The Commission has issued the enclosed Amendment No. 36 to Facility License No. DPR-63 for Unit No. 1 of the Nine Mile Point Nuclear Station. The amendment consists of changes to the license and Technical Specifications in response to your request forwarded by letter dated June 28, 1979.

NINE MILE POINT NUCLEAR STATION, UNIT NO. 1

AMENDMENT TO FACILITY OPERATING LICENSE

Amendment No. 36
License No. DPR-63

Figure 3.1.7.aa LIMITING POWER FLOW LINE

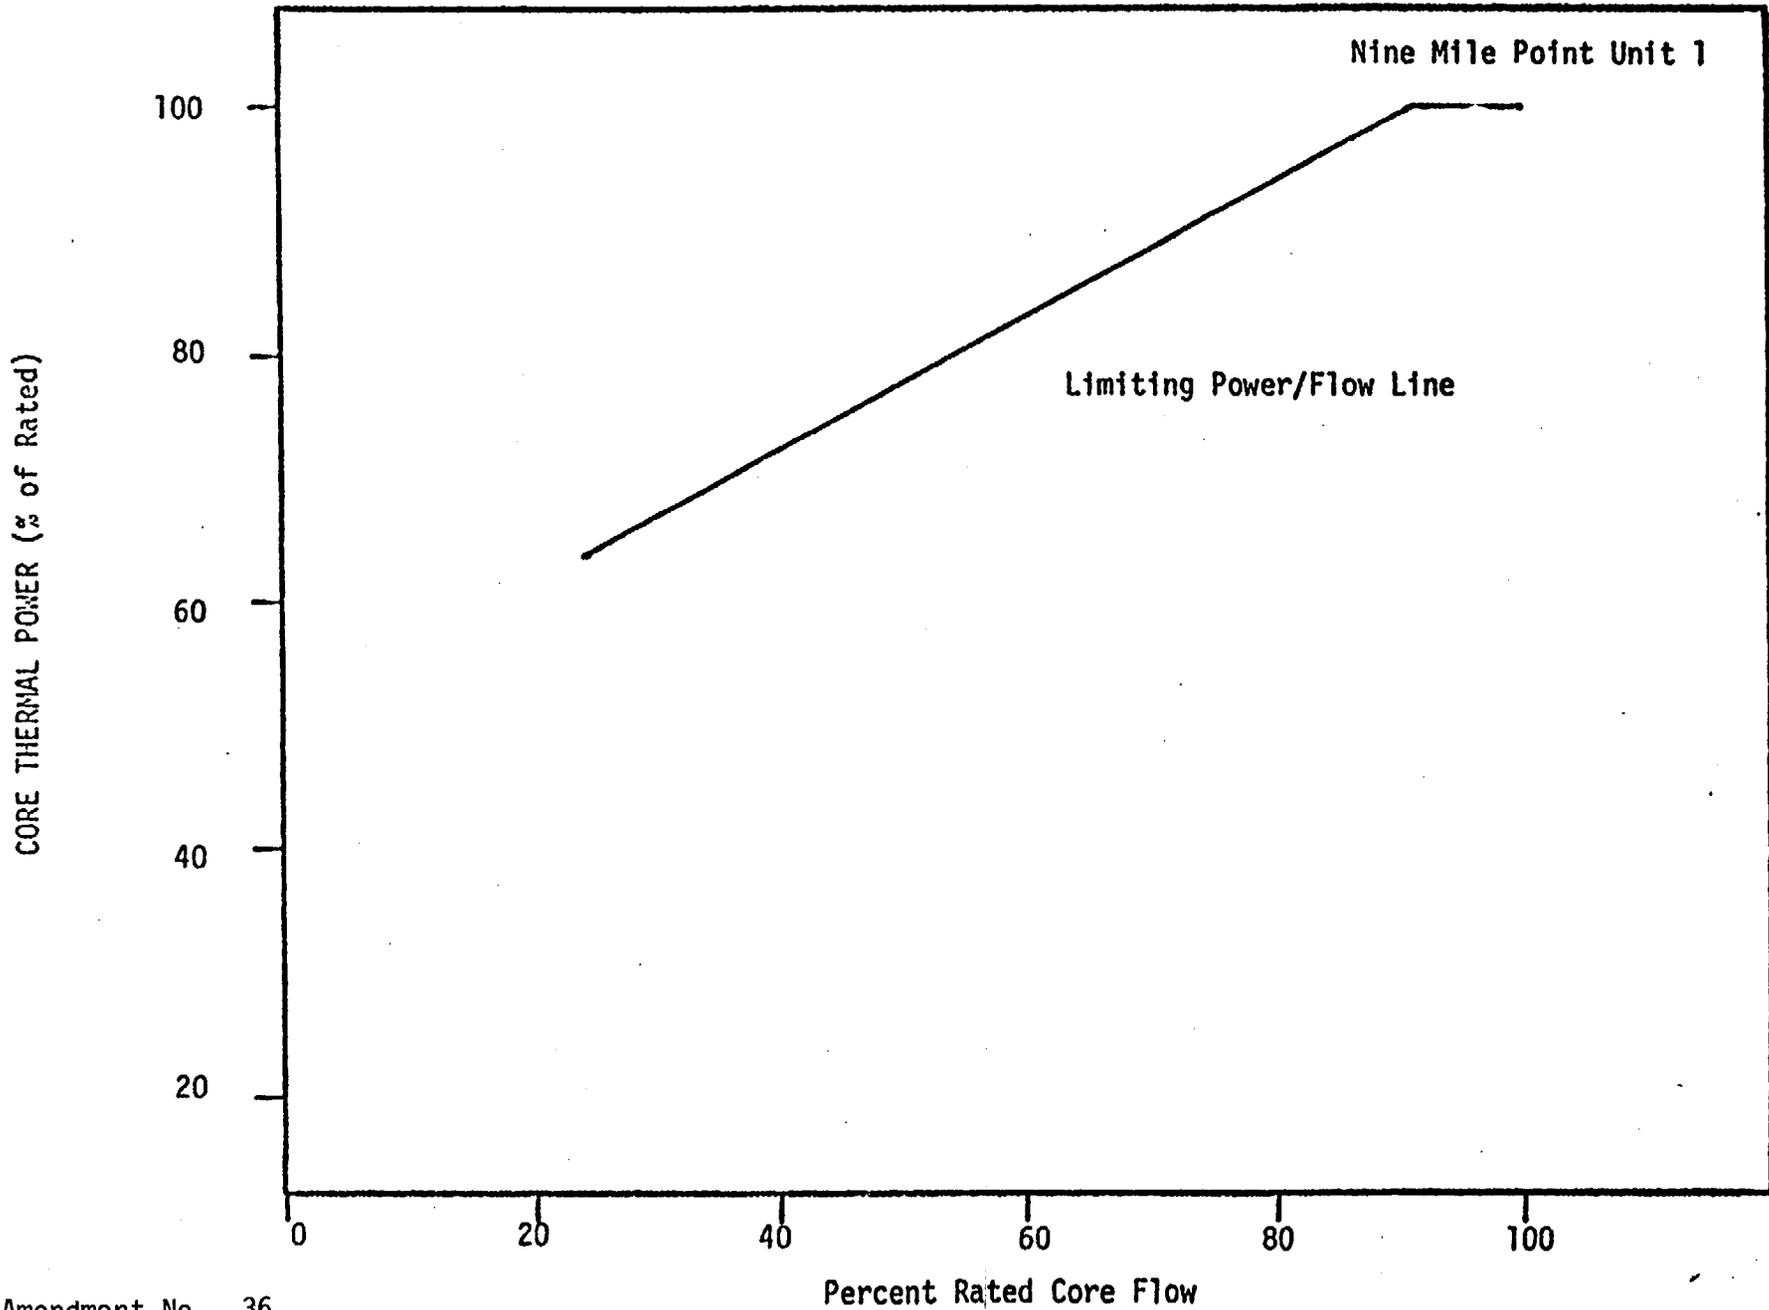
The amendment consists of changes to the Technical Specifications to modify the power-to-flow curve and allow additional operational flexibility during plant load changes. In addition, corrections have been made to the license to reflect the present power limitations at the end of cycle. These corrections were verbally agreed to by members of your staff.

By letter dated June 28, 1979, (1) Niagara Mohawk Power Corporation (the licensee) proposed changes (2) to the limiting power-to-flow line appearing in the Technical Specifications for Nine Mile Point 1 (NMP-1). The requested change to the power-to-flow curve is intended to provide additional operational flexibility during plant load changes. The safety analyses supporting the proposed technical specification change is provided in Reference 3. The proposed modification to the operating limit is substantially similar to an earlier approved revision to the power-to-flow line. However, the new proposal does not require or include changes to any other plant operating limits or limiting safety-system settings which was the case in the previously approved revision.

The limiting power-to-flow curve represents the maximum permissible operating steady-state core thermal power as a function of core flow. Increasing the power-to-flow curve would allow reactor operation at a correspondingly higher power for the same flow. Accordingly, the initial steady-state condition for events postulated for NMP-1 would be affected by the proposed change. To show that the limiting transients and accidents will not violate related plant safety criteria, the events which could be affected by the proposed change were re-analyzed by the licensee for this application. The analytical codes and methods used for the revised safety analyses are described in Reference 4. As described in Reference 5 these analytical procedures have been previously reviewed and accepted by the staff. The plant and cycle-specific inputs to these analyses are consistent with the revised power-to-flow curve and the most recent reload safety analyses (6, 7) for NMP-1.

Based on our review, we find that the proposed modified limiting power-to-flow curve is consistent with and adequately supported by the revised safety analysis. Accordingly operation in accordance with the revised technical specification power-to-flow curve is acceptable.
